ABERDEEN SECOND ADDITION

TO WICHITA, SEDGWICK COUNTY, KANSAS

RE: S/D 96-18, Final Plat of the ABERDEEN 2ND ADDITION

RE: S/D 96-18, Preliminary Plat of the ABERDEEN 2ND ADDITION

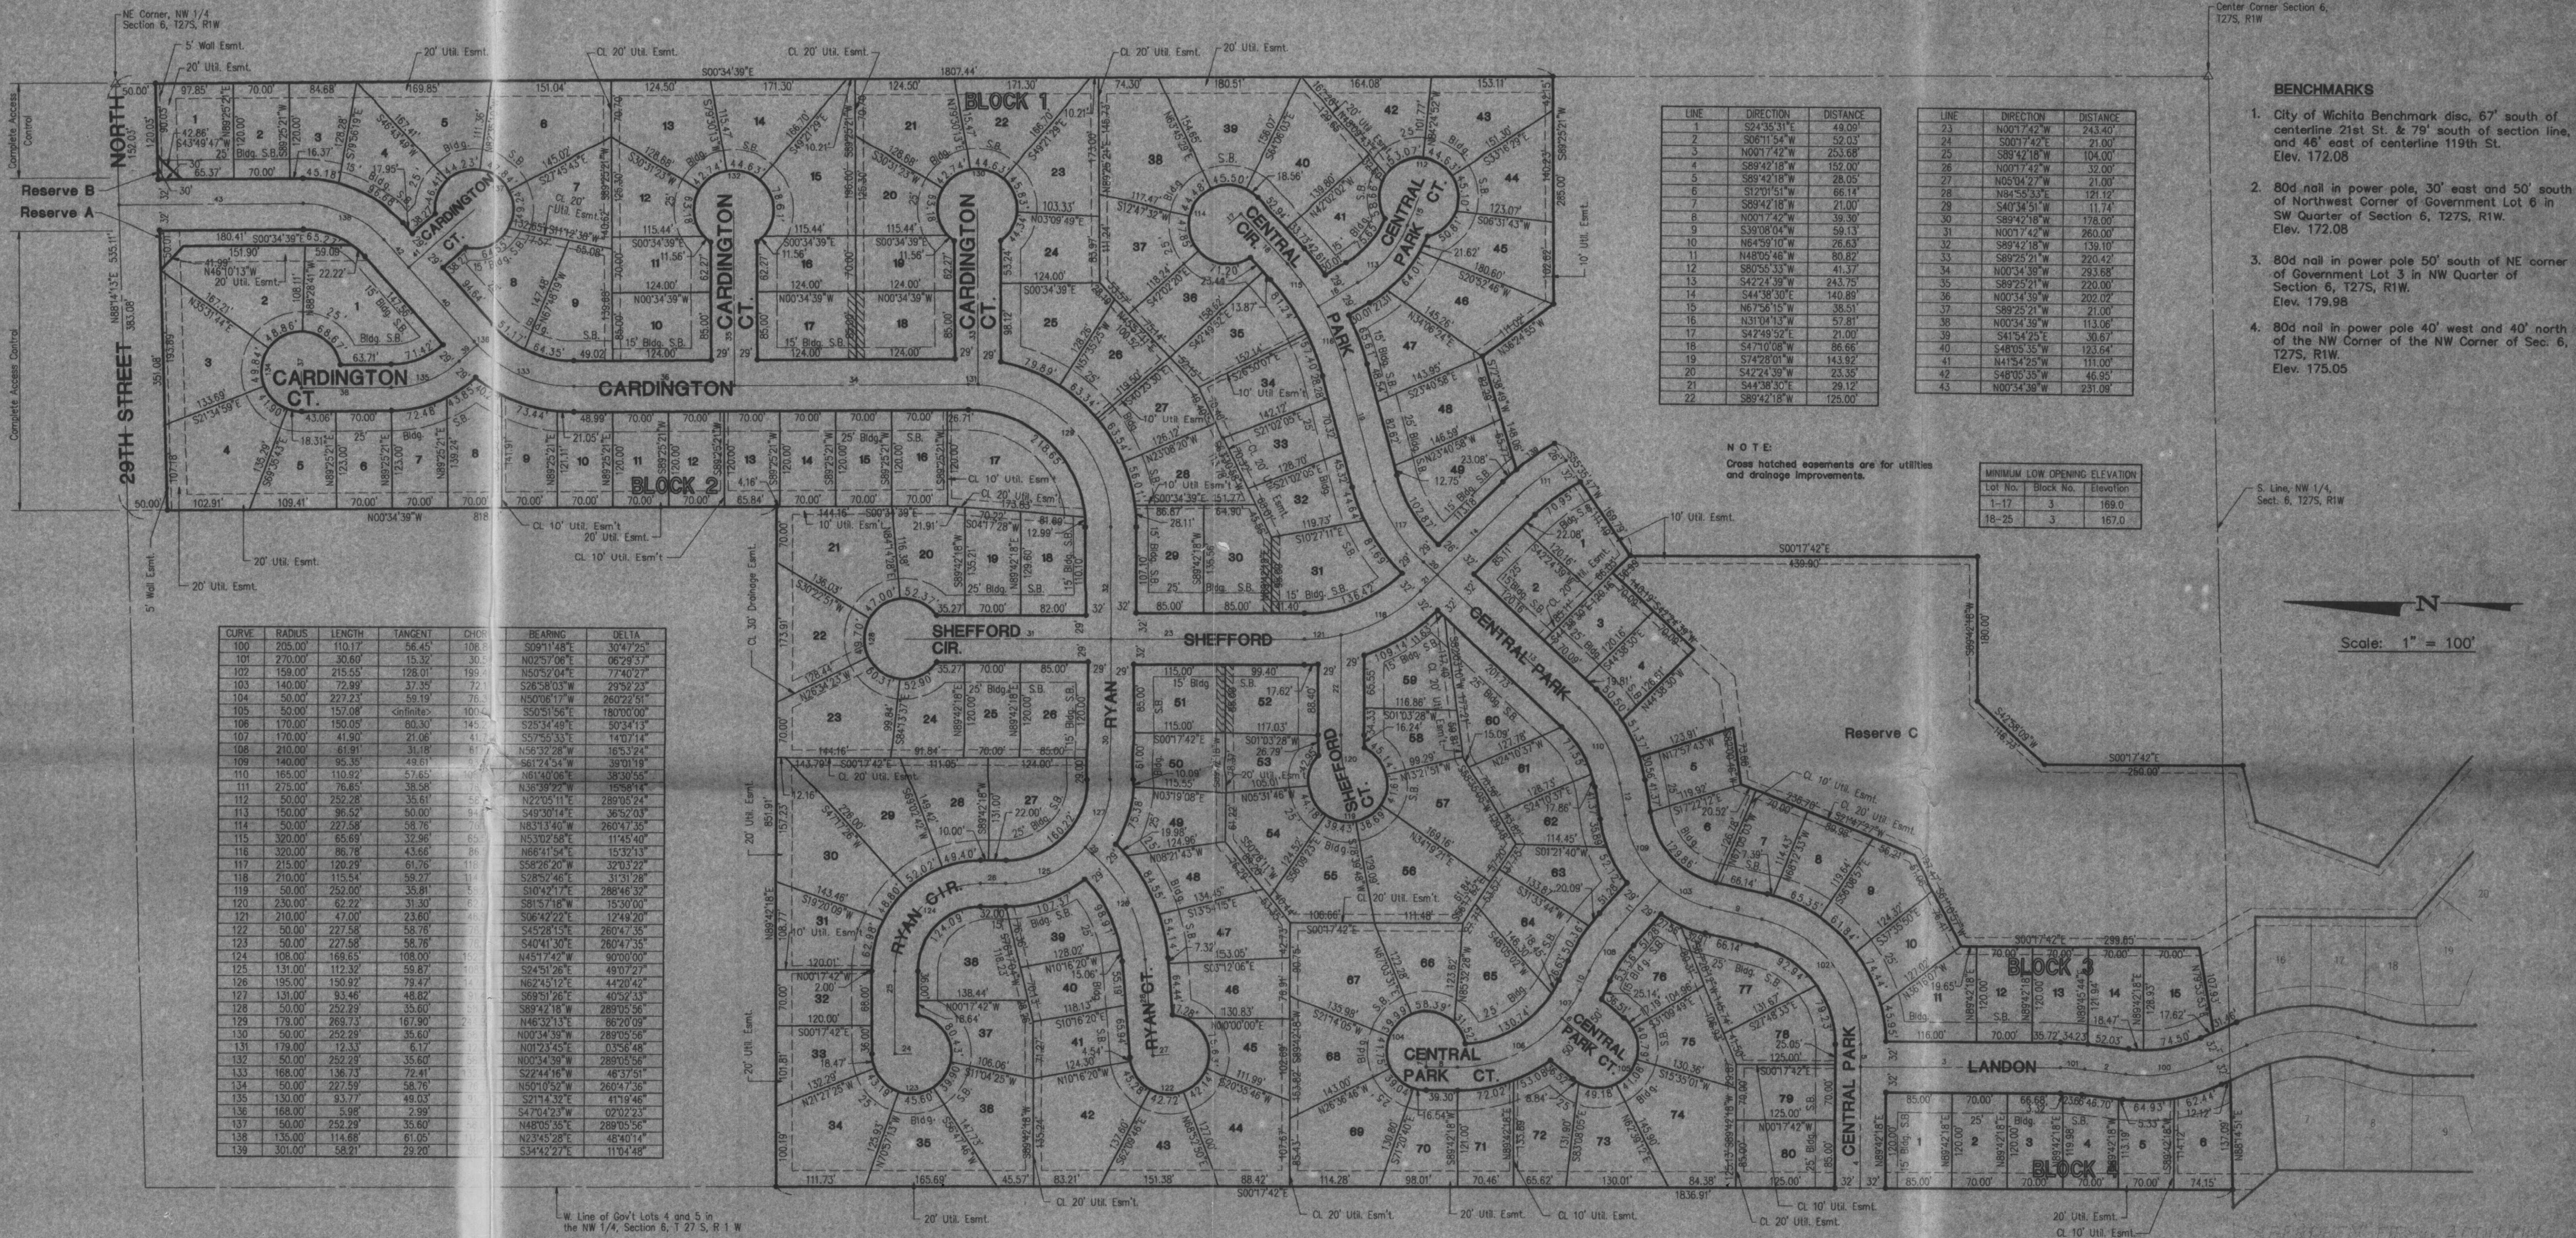
- M. Since this property will need to establish minimum building pad elevations, the face of the plat shall reference the location and elevation of permanent on-site and off-site benchmarks. Section 5-402(N).

- N. The platting of the minimum building pad elevations shall be noted on the face of the final plat tracing as well as in the plat's text.
- O. The applicant shall submit a covenant which provides for four (4) off-street parking spaces per dwelling unit on each lot which abuts a 58-foot street. The covenant shall inventory the affected lots by lot and block number and shall state that the covenant runs with the land and is binding on future owners and assigns.

- Q. On the final plat tracing, as indicated by the platlor's text, a utility easement shall be provided within Reserve B.
- R. On the final plat tracing, dashed lines shall be used where the streets (Chartwell, Central Park, etc.) terminate at this plat's perimeter. Solid lines are used to indicate private streets.

- Y. The final plat shall indicate the utility easements requested by K.G. & E. which are indicated on the enclosed "marked" copy of the plat.
- Z. As noted by City Engineering, prior to submitting the final plat tracing for City Council review, additional information will be needed in regards to this site's drainage plan. Also, the applicant shall confirm if this site is impacted by high ground water levels and if necessary building pad elevations will be required for any such lots.
